Review of KAVHA Safety Hazard Investigation

This desktop review is provided to the KAVHA Advisory Committee of the Department of Infrastructure, Regional Development and Cities (the Department) in response to their Approach to Market (Ref: TERR18/0310-01, dated 7 November 2018). It is intended as a peer review of the proposed rectification works on Norfolk Island prior to the project proceeding to a detailed design stage. This peer review considers the *KAVHA Safety Hazard Investigations Report* prepared by AECOM in October 2018 against the recommendations made in the *KAVHA Safety Hazard Scoping Study* prepared by GML Heritage in June 2018.

Figure 9 – Proposed works for underpinning of arches [Source: AECOM]

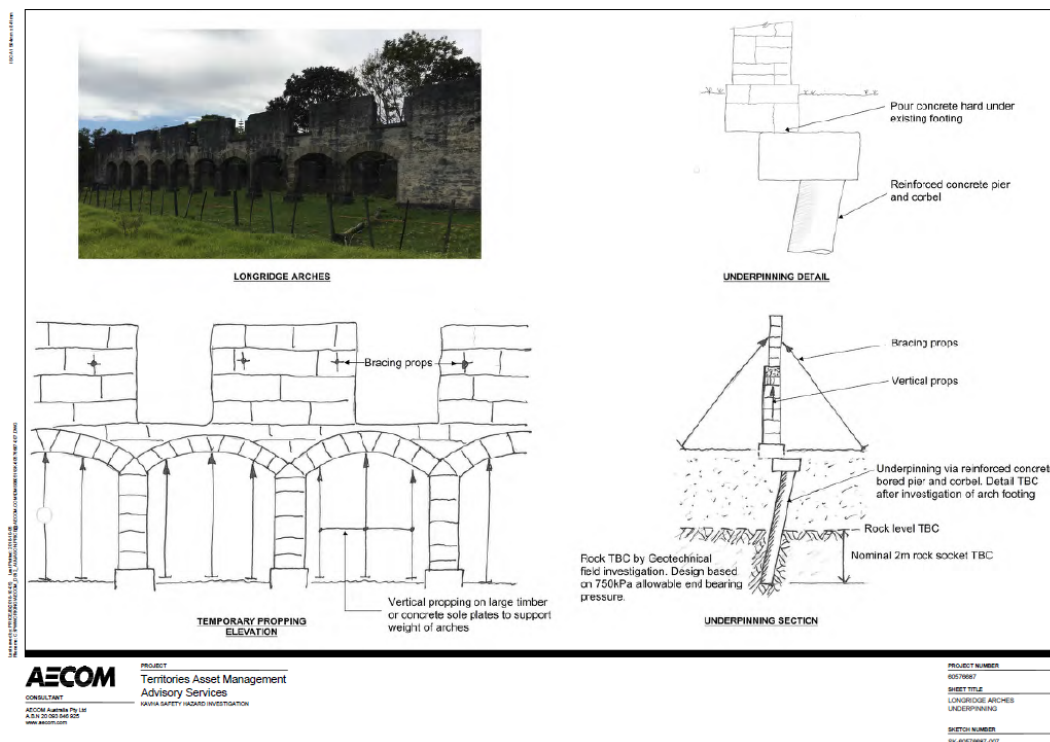
Purcell agree from our desktop review that the initial focus of any proposed works should be to reduce the pressure on the foundations from the eccentricity of the wall by way of underpinning the footings. The introduction of extensive bracing structures alone would ultimately not address the issue. We agree with AECOM that the "less intrusive option for the stabilisation of the Arches will be most in keeping with the conservation aims of the EPBC Act and the Burra Charter." The exact method of inserting underpinning needs to be investigated further, and Purcell question whether the proposed temporary propping of the wall (below) during this process is anticipated to actually remove the lean in the wall at the same time. The exact form, material and detail of the necessary propping should be predicated on minimising the visual intrusion of any new structure on the existing wall while at the same time offering the best long-term structural stability. We do not consider the rebuilding of roof or floor elements in some form of "interpretation" to be best heritage practice in this instance.

Purcell also agree that given the potential impact of any such works on original fabric and archaeological remains that a heritage impact statement be developed to assess the significance of the proposed changes, recommend appropriate mitigations, and support approvals as required.
